Re: **DR/CU/EID/EIR 1101974–Chevron Energy and Hydrogen Renewal Project; Appeal of CBE et al., response to new claims relevant to oil input quality cap: Sahu Report; and new claims regarding flaring**

Chevron Energy and Hydrogen Renewal Project Appeal Technical Response to late-filed comments

Hourly profile of flare sulfur emissions and sulfur dioxide concentration in air at fence line ground-level monitors (GLMs) and ambient (7th St.) monitor: Chevron Richmond Refinery

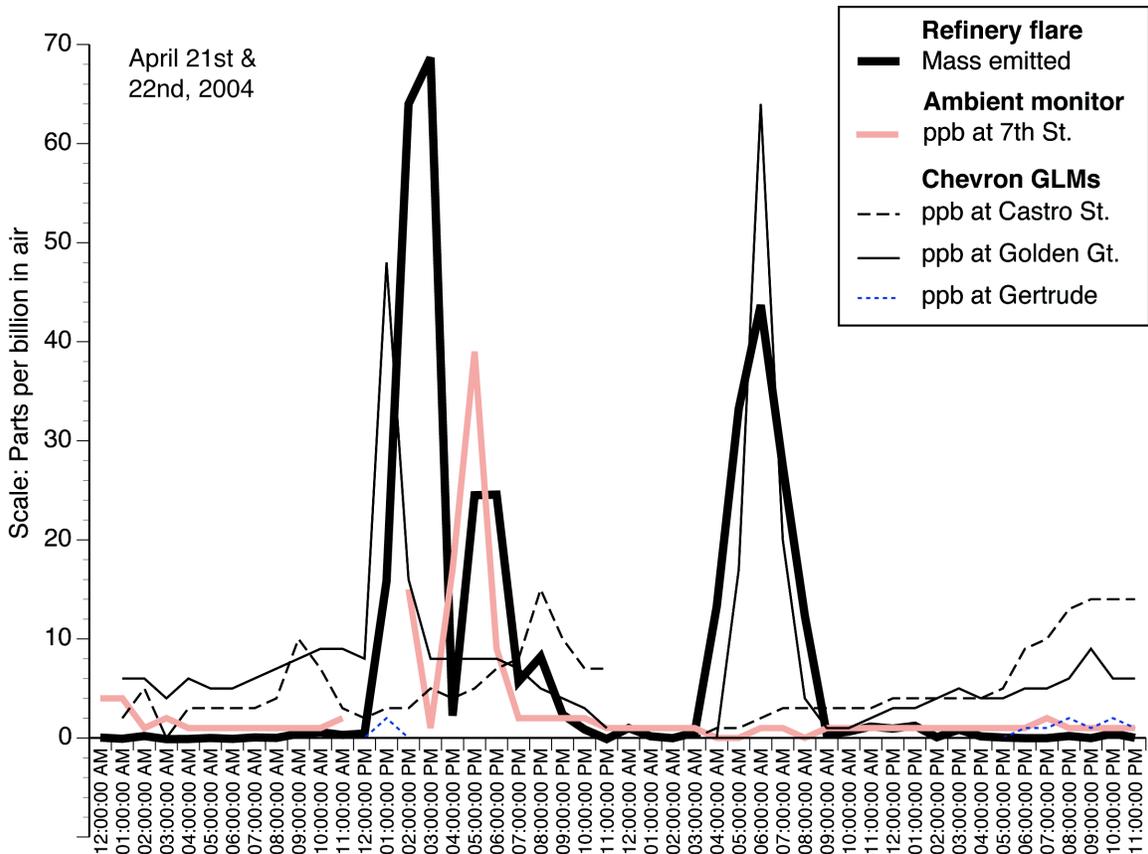
Chevron asserts that flare impacts should be assessed from long-term average flare emissions instead of incident emissions. Chamberlin 6/5/08 Testimony. Chevron's assertion is incorrect. Flaring is primarily an *acute exposure* problem.

This chart illustrates hourly pollution in nearby air over two days of intermittent flaring. The thick black line shows sulfur dioxide (SO₂) emissions from Chevron's flares. The other lines show SO₂ concentrations in ambient air measured at four monitors. High concentrations appear in the chart as vertical peaks.

Ambient air concentrations peak at one monitor or another during part of all of every peak in flare emissions. Fence line concentrations peak earlier and higher than those measured at the more distant 7th Street monitor. Different monitors peak at different levels and at different times. These observations describe a large, changing emission plume that is more concentrated near the refinery than further away, and shifts in the wind to hit or miss various monitors over the duration of the flaring.

April 21 and 22, 2004 Chevron Flaring Event
Maximum 1-hour SO₂ Air Concentration (ppb)

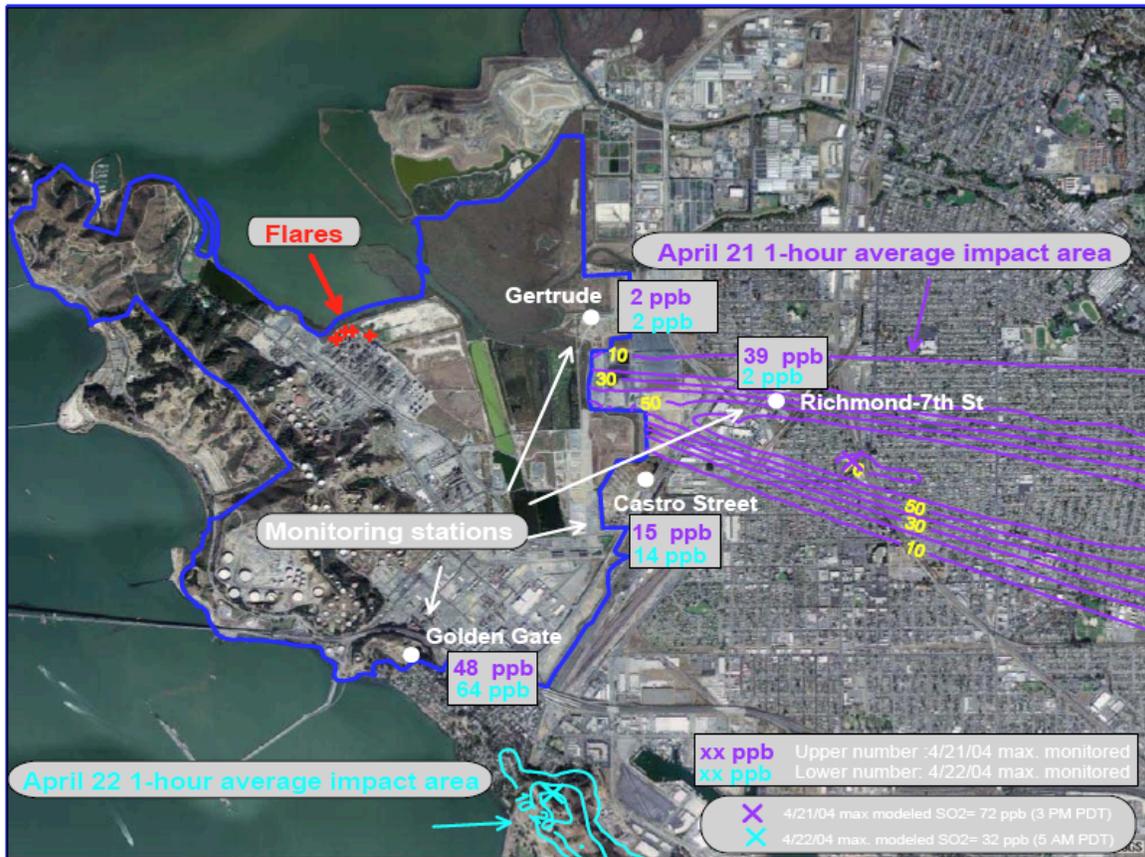
Results from Air District modeling of these two days of flaring are shown on this map. The ambient air monitors discussed above are shown as white dots. Purple lines show the modeled emissions plumes (impact areas, or “isopleths”) for the first day of flaring: light blue lines show the plumes for the second day of flaring. District staff found that: “these isopleths show an impact on the nearby community.” 3/3/06 AQMD Staff Rpt. The flare impacts predicted from emissions modeling match those measured.

Sulfur in crude oil v. sulfur in emissions from 49 hydrocracker or hydrotreater flaring incidents at four Bay Area refineries, January 1, 2004–August 30, 2006.^a

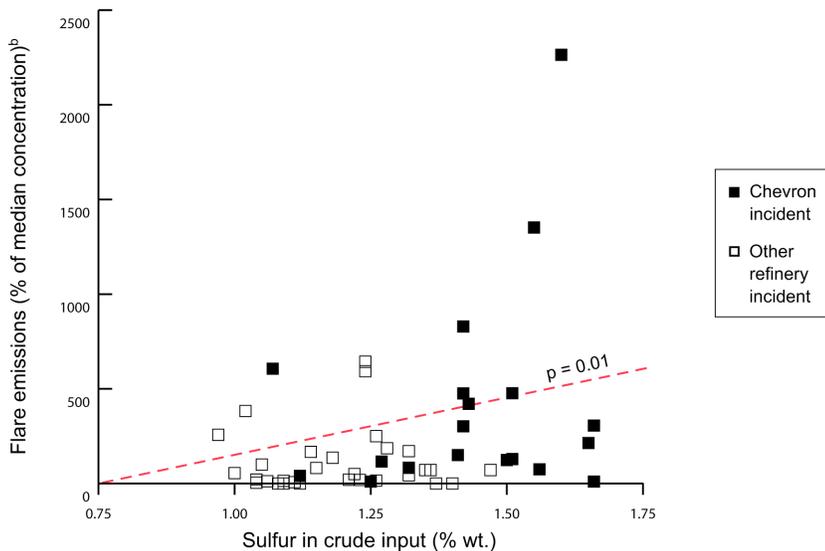
The chart Chevron referenced in questioning the environmental significance of the flare incidents shown is copied below. We presented this chart on June 5, 2008 to illustrate that the intuitively obvious “dirty in-dirty out” effect, where more polluted input oil creates more pollutant release, is documented by specific local data. Second—and this was news to many of us—Chevron’s crude switch has *already begun* to increase its flare emissions during the months when the Refinery runs relatively higher-sulfur oil blends. The answer to Chevron’s first question is that every incident shown is significant as defined by the Air District criteria for environmental significance discussed above.

Chevron also questioned whether the number of data points (incidents) is sufficient to draw firm conclusions about a significant increase. Chamberlin 6/5/08. For the point of this chart, the data appear to support an increase in flare gas sulfur content with increasing crude input sulfur content that is significant at $p = 0.01$ in regression analysis. For *environmental* significance, we can look also at the number of days of flaring above 500,000 SCF/d and/or 500 lb/d SO₂, and include *all* Refinery sources. (Because it tracks sulfur the chart above looks only at refinery processes that remove sulfur from oil.)

The frequency *and* magnitude of flaring drive its environmental significance. Going back to page 4, the dashed line in the scatter chart representing the central trend (from regression analysis) suggests that on average, significant flaring emission concentrations increased by approximately five times (500%) as crude sulfur input increased by an increment of 0.5% sulfur (from 1-1.5%). Flaring frequency more than doubled as crude sulfur increased by this same 0.5% increment. Thus, environmentally significant flaring occurred more than twice as often and its emissions appear to have been about five times as concentrated when Chevron's crude input blends had 0.5% higher sulfur content.

**Increase in significant flare incidents with higher sulfur crude oil inputs:
Richmond Refinery data from January 1, 2004 through April 30, 2008**

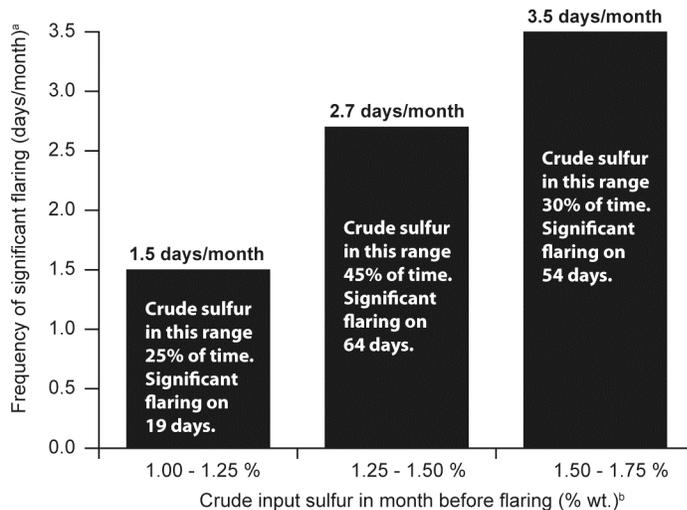
The bar chart below shows the same monthly crude oil inputs as the chart above. It shows data for all environmentally significant flaring at Richmond over a recent period of more than four years. Review of this chart shows a clear change in the frequency of this flaring between months of relatively lower and higher sulfur crude input.

Flaring frequency more than doubled, from 1.5 to 3.5 days/month, as crude sulfur input increased by 0.5% sulfur, from the 1-1.25% range to the 1.5-1.75% range. It also increased step-wise: In the middle crude input range (1.25-1.5%) the frequency was in the middle at 2.7 days/month. These results are based on a total of 137 observations (137 significant flare-days). The smallest of the data subsets compared still included 19 observations and comprised 25% of this 4.3-year period.
